Office Action Summary

10/774,597

SYKORA, SEAN R.

The drawings are objected to as failing to comply with 37 CFR 1.84(p)(5) because they do not include the following reference sign(s) mentioned in the description: "length substantially shorter than the length of said side-less edge" is not shown in the drawings. Corrected drawing sheets in compliance with 37 CFR 1.121(d) are required in reply to the Office action to avoid abandonment of the application. Any amended replacement drawing sheet should include all of the figures appearing on the immediate prior version of the sheet, even if only one figure is being amended. Each drawing sheet submitted after the filing date of an application must be labeled in the top margin as either "Replacement Sheet" or "New Sheet" pursuant to 37 CFR 1.121(d). If the changes are not accepted by the examiner, the applicant will be notified and informed of any required corrective action in the next Office action. The objection to the drawings will not be held in abeyance.

Fig. 4

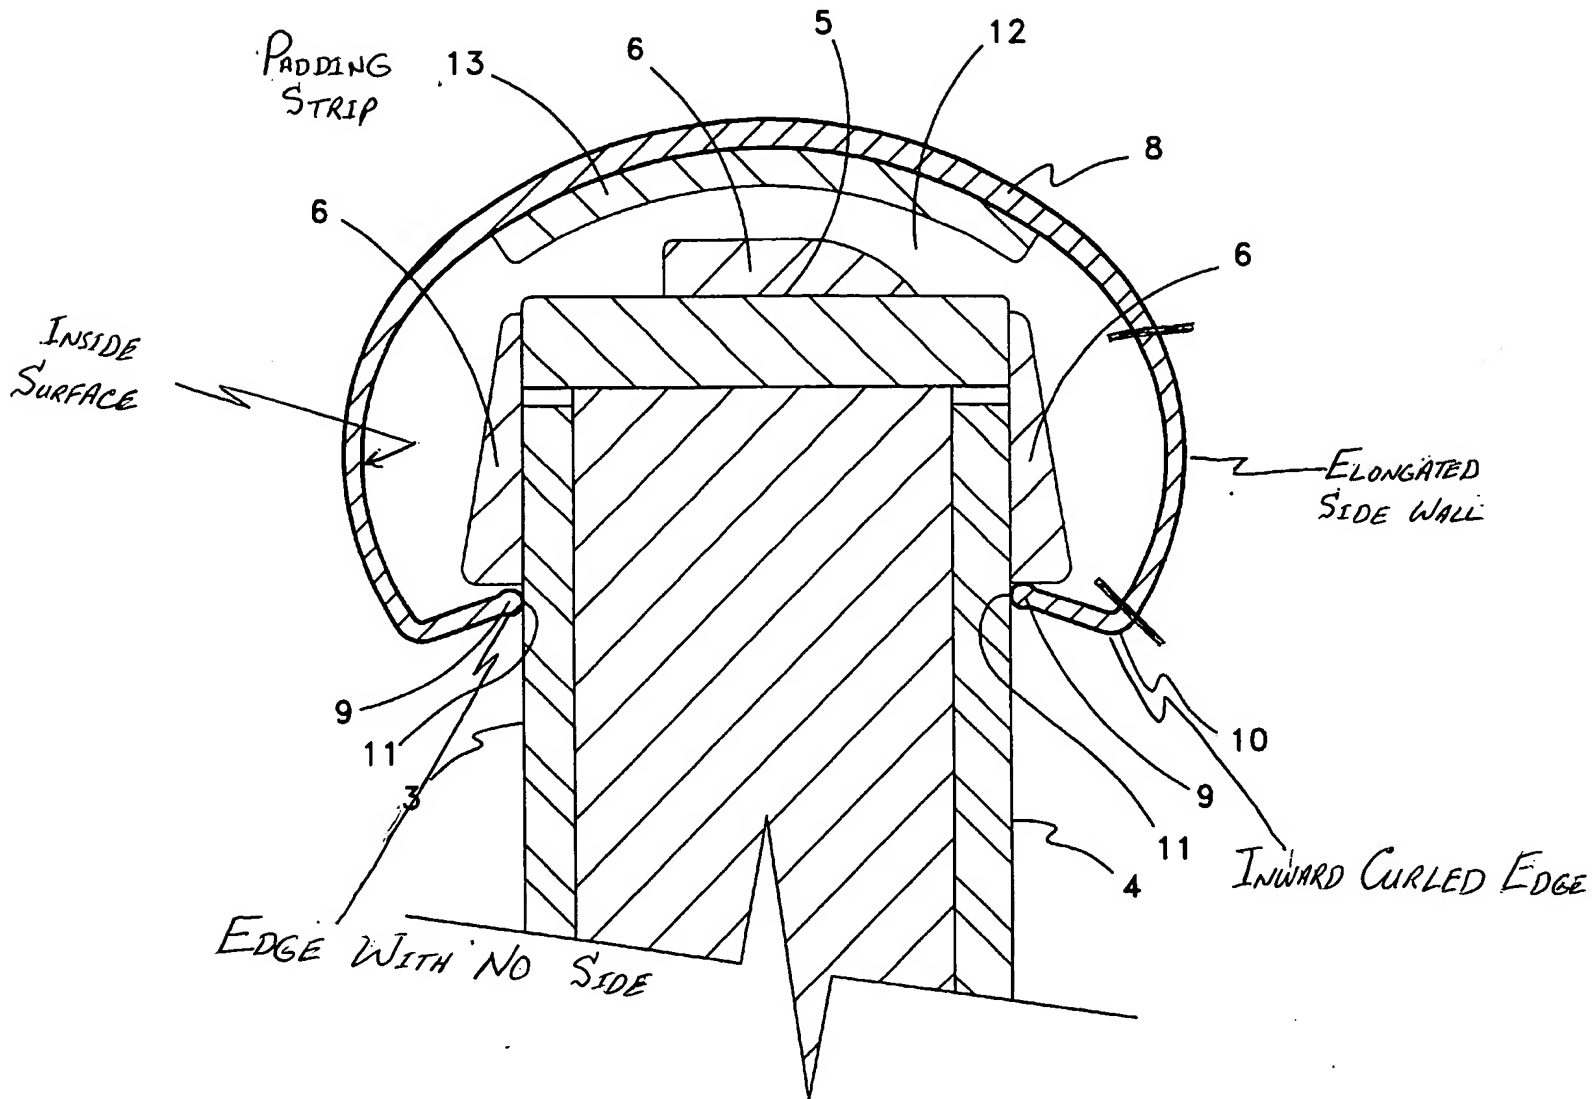
In regard to claim 1, Homolka discloses a doorframe protector (Fig. 9) comprising an elongated, flexible (column 5, lines 40-43) latch-side protector having an inside surface (see Marked Figure), the latch-side protector having pair of opposing longitudinal side walls (see Fig. 4), each of the side walls having an edge curled inward toward the inside surface (see Marked Figure).

In regard to claim 2, Homolka discloses a doorframe protector comprising at least one strip 13 of padding material disposed longitudinally along the inside surface (see Fig. 4).

In regard to claim 5, Homolka discloses a doorframe protector comprising at least one strip 13 of padding material disposed longitudinally along the inside surface (see Fig. 4).

In regard to claims 10 and 11, Homolka discloses a doorframe protector comprising at least one strip 13 of padding material disposed longitudinally along the inside surface of the latch-side protector and or the hinge-side protector (see Fig. 4).

Fig. 9

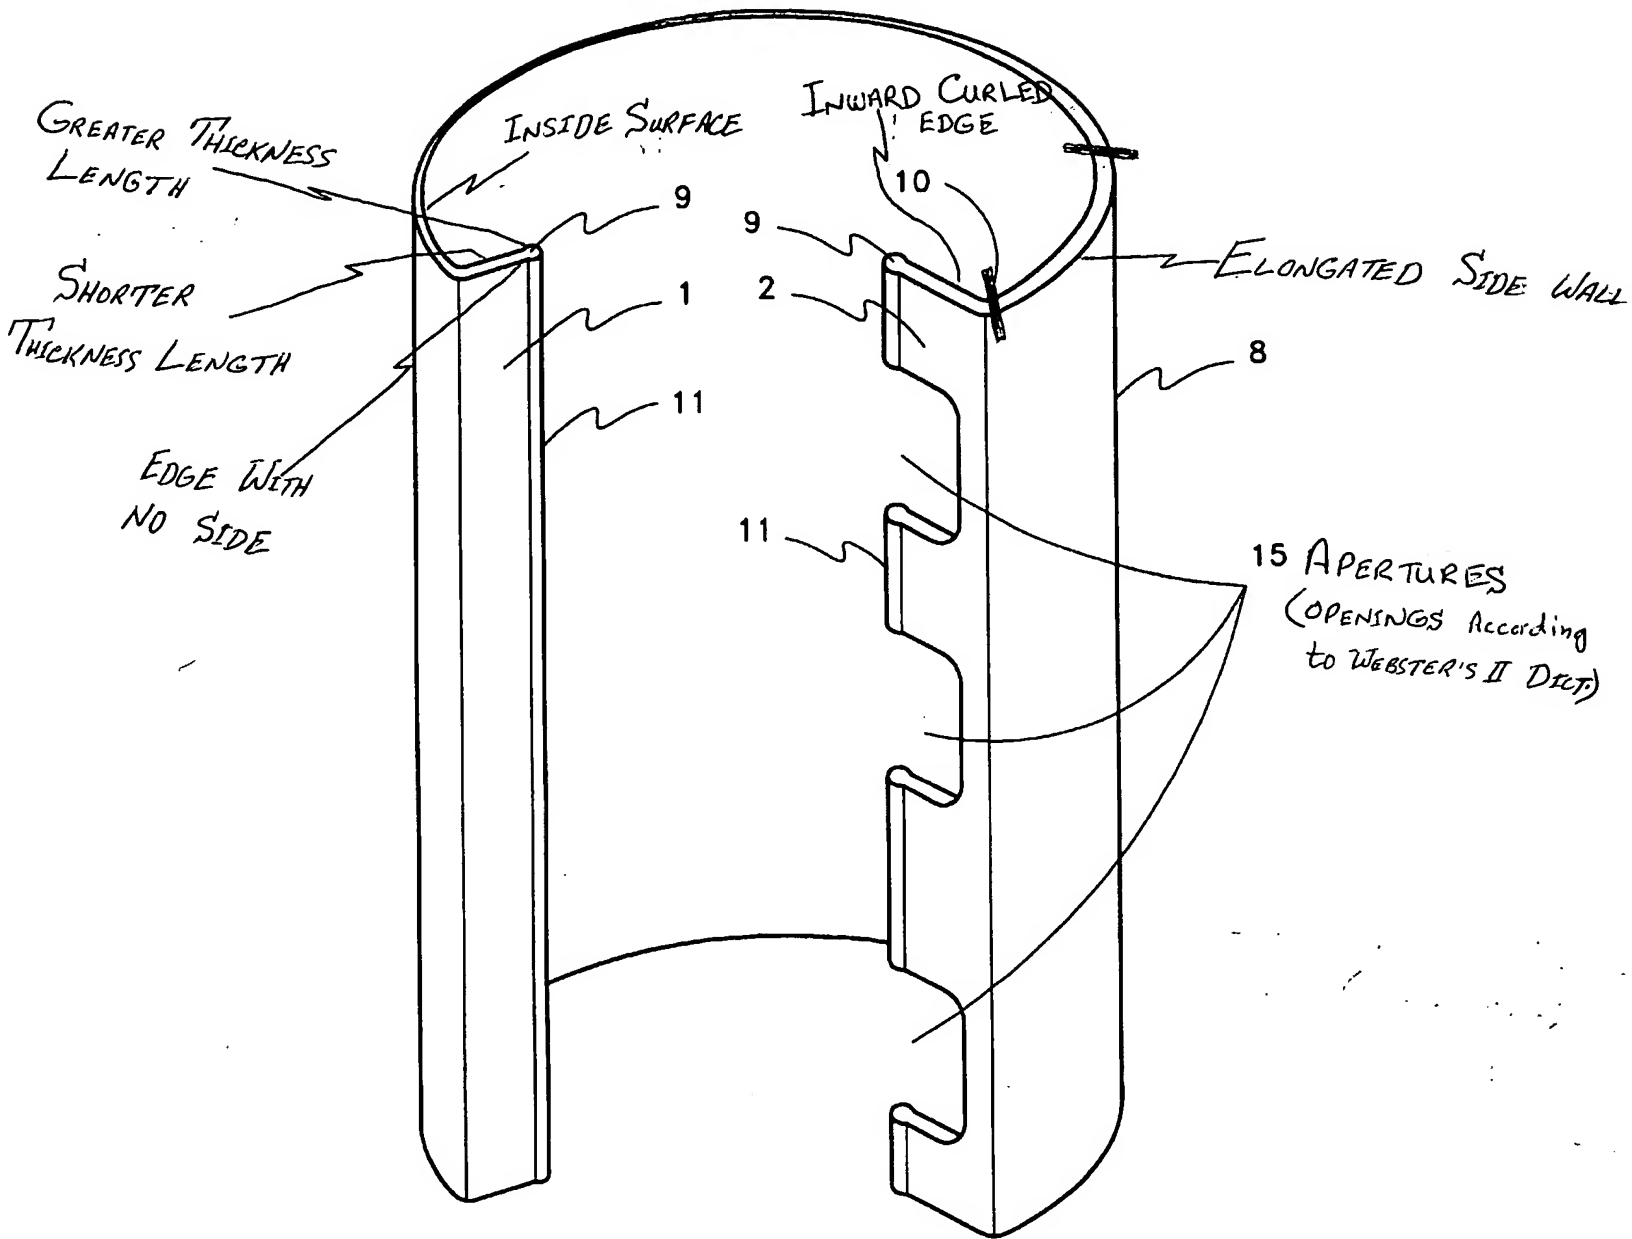
In regard to claim 3, Homolka discloses a doorframe protector comprising a plurality of apertures 15 (Webster's II Dictionary definition) defined in and longitudinally spaced along the side wall (see Fig. 9).

In regard to claim 4, Homolka discloses a doorframe protector (Fig. 9) comprising an elongated, flexible (column 5, lines 40-43) hinge-side protector having an inside surface (see Marked Figure), the hinge-side protector having a first longitudinal side wall (see Fig. 9), having an edge curled inward toward the inside surface (see Marked Figure), the hinge-side protector having a side-less edge (see Marked Figure) opposite the side wall.

In regard to claim 7, Homolka discloses a doorframe protector comprising a second (see Fig. 9) longitudinal side wall disposed along the side-less edge, the second side wall having an edge curled inward toward the inside surface (see Marked Figure), the second side wall having a length substantially shorter than the length of the side-less edge (see Marked Figure).

In regard to claim 8, Homolka discloses a doorframe protector comprising the second side wall centered along the side-less edge (see Marked Figure).

In regard to claim 12, Homolka discloses a doorframe protector comprising a plurality of apertures 15 (Webster's II Dictionary definition) defined in and longitudinally spaced along the side wall of the latch-side protector (see Fig. 9).

In regard to claim 14, Homolka discloses a doorframe protector wherein the hinge-side protector comprises a second (see Fig. 9) longitudinal side wall disposed along the side-less edge, the second side wall having an edge curled inward toward the inside surface (see Marked Figure), the second side wall having a length substantially shorter than the length of the side-less edge (see Marked Figure).

In regard to claim 15, Homolka discloses a doorframe protector comprising the second side wall centered along the side-less edge (see Marked Figure).

HINGE-SIDE PROTECTOR (SECURING PEECE)
AND/OR
LATCH-SIDE PROTECTOR
